ADDENDUM 04

Date: March 17, 2022

Project Name: Gregg County Parking Garage and Office

SHA Project No.: 20011

A1.1

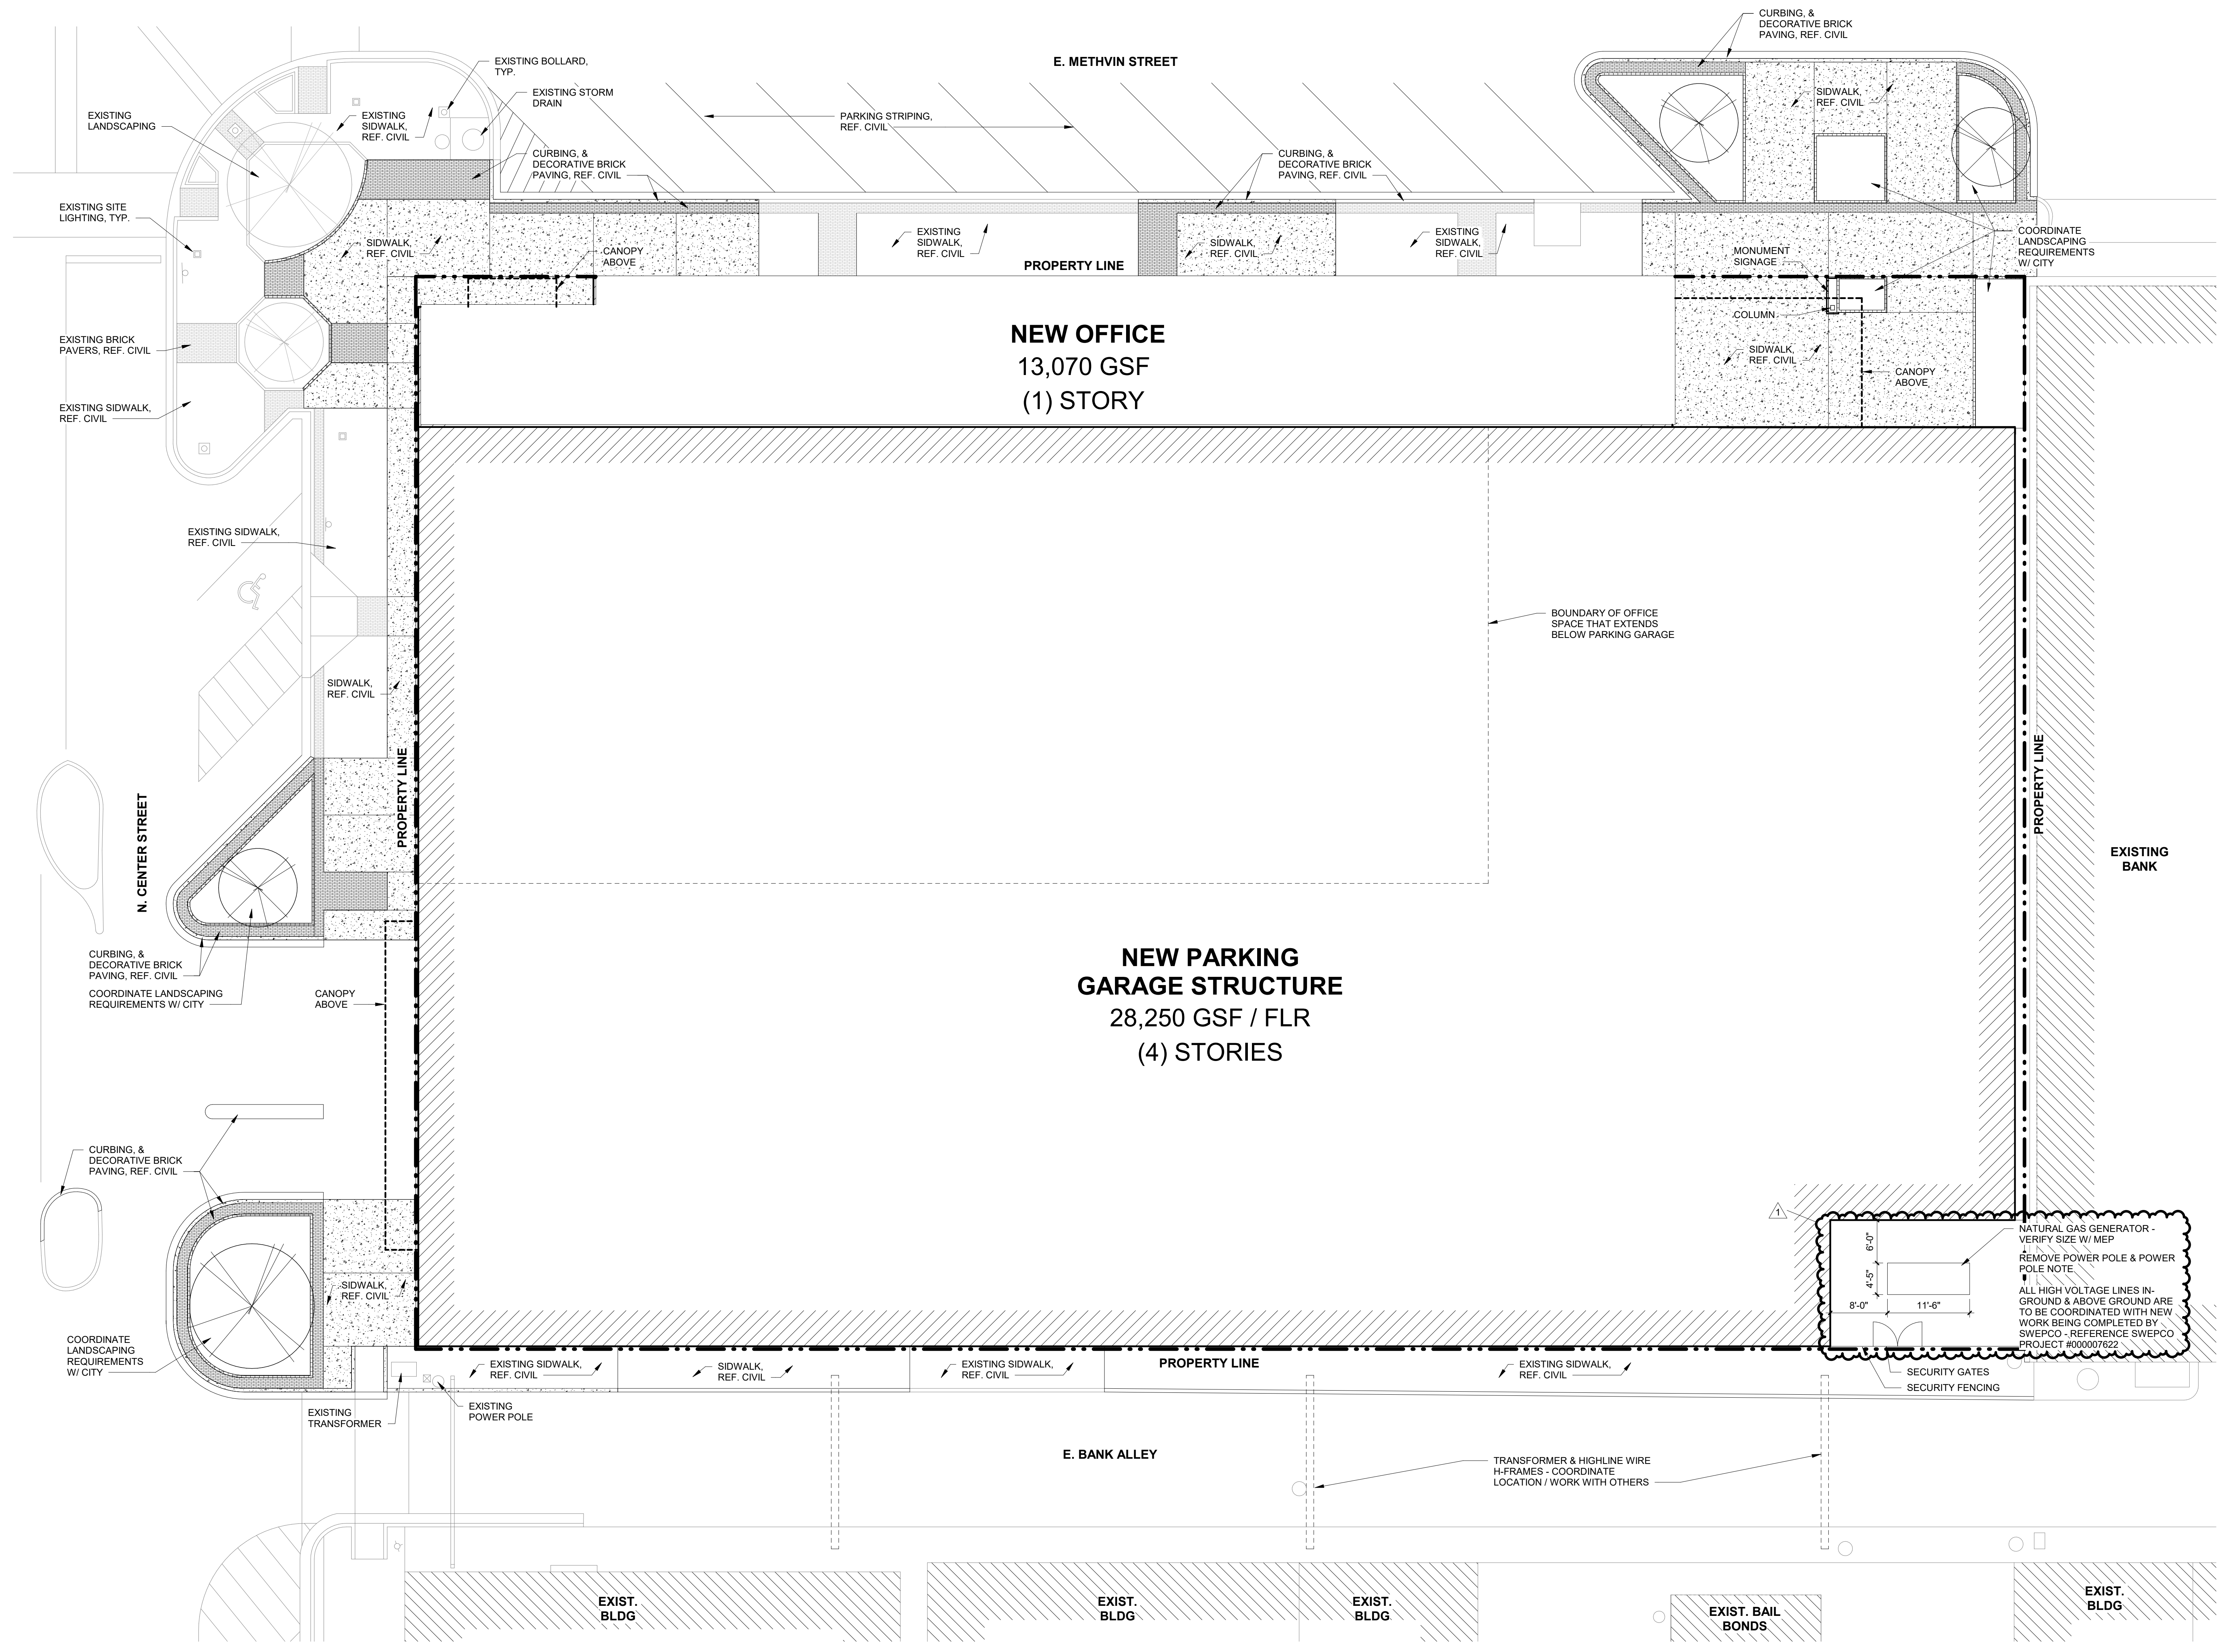
- Sheet A1.1 was updated to revise the NE corner annotations related to the generator and power.
- For the sake of naming consistency and clarity, the date and the words "Addendum 01" located within the titleblock of all addendum sheets issued out on 03/09/2022, as a part of Addendum 03, were revised to read "Addendum 03" and re-dated to 03/09/22. We wanted to make sure it was clear that the revised sheets issued with addendum 03 were named properly in accordance with the naming structure observed on the public advertisement, here: <https://www.co.gregg.tx.us/construction-manager-risk-cmar-gregg-county-parking-facility-project>

ENLARGED PLAN - NE - OFFICE LEVEL & GARAGE TIER G | 1
SCALE: 1/4" = 1'-0" | A2.7

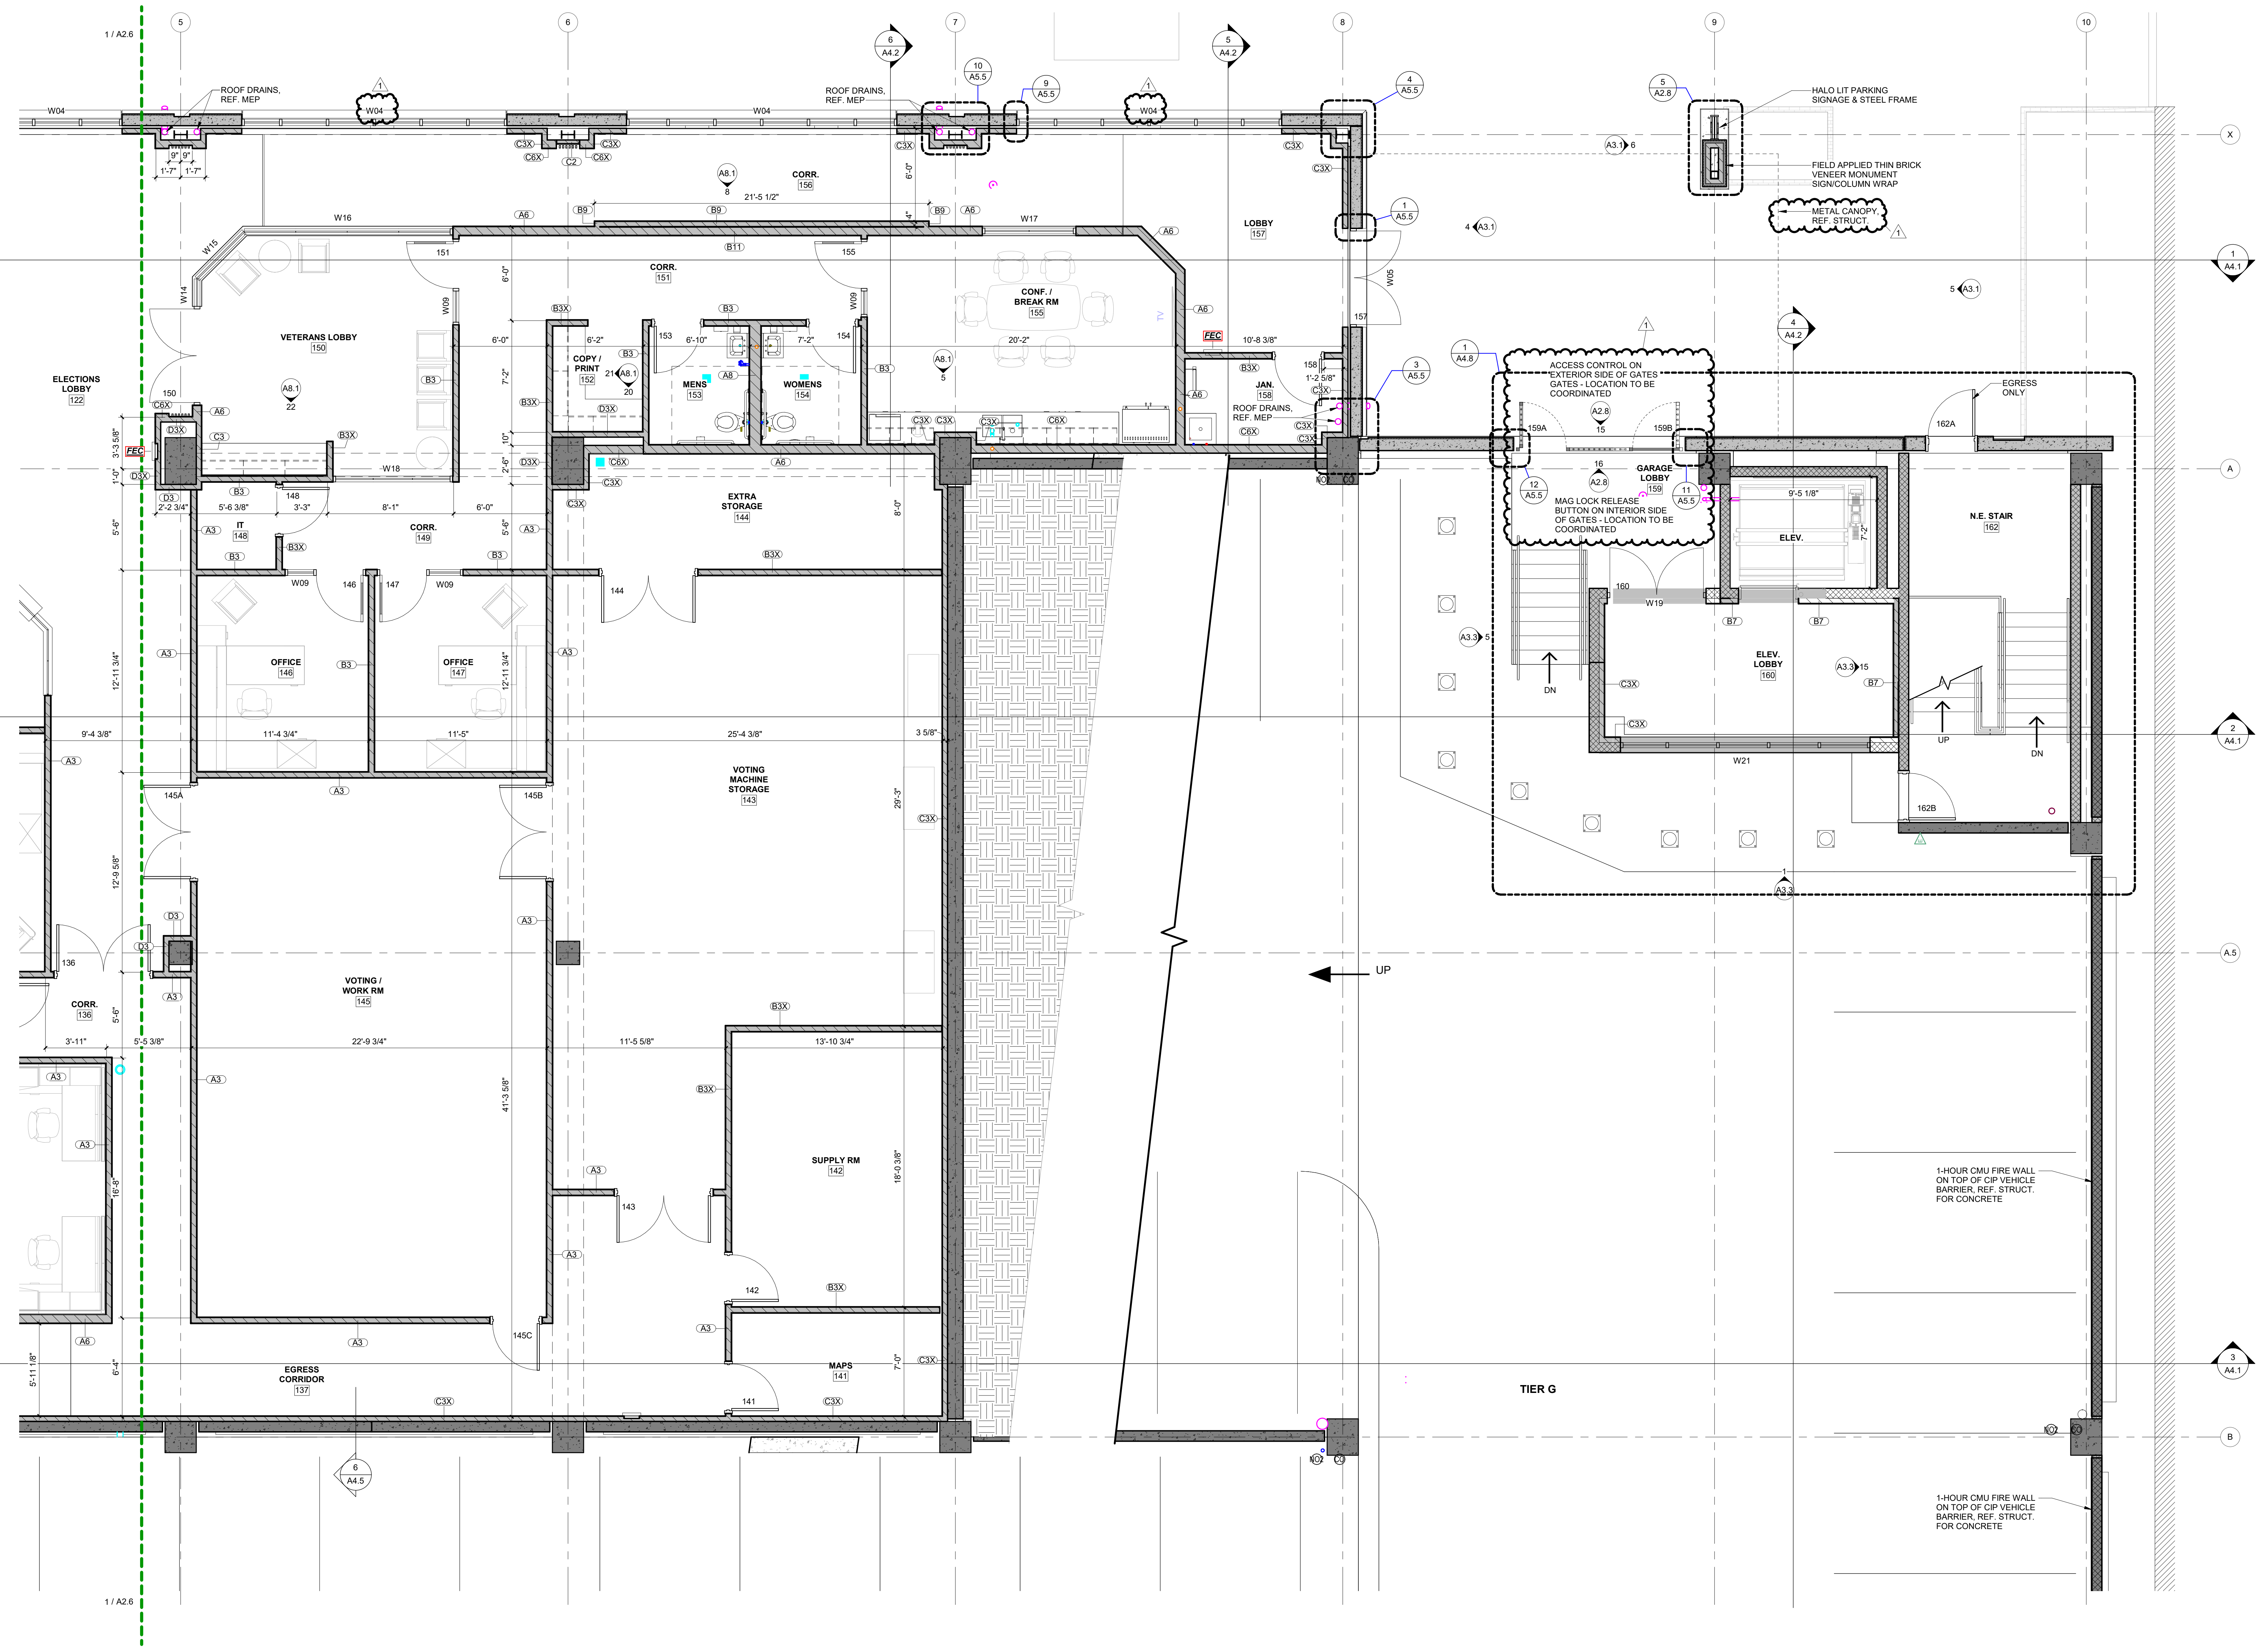
Question #A16: On the North elevation on sheet A3.1, three of the six large windows are indicated to be window type 'W05'; however, 'W05' shown on sheet A6.1 is simply a transom door frame. These same three windows are also incorrectly marked on enlarged plan sheets A2.6 and A2.7. Please clarify

Response #A16: We revised sheet(s) A2.6, A2.7 & A3.1 to correct the storefronts in question to read type "W04".
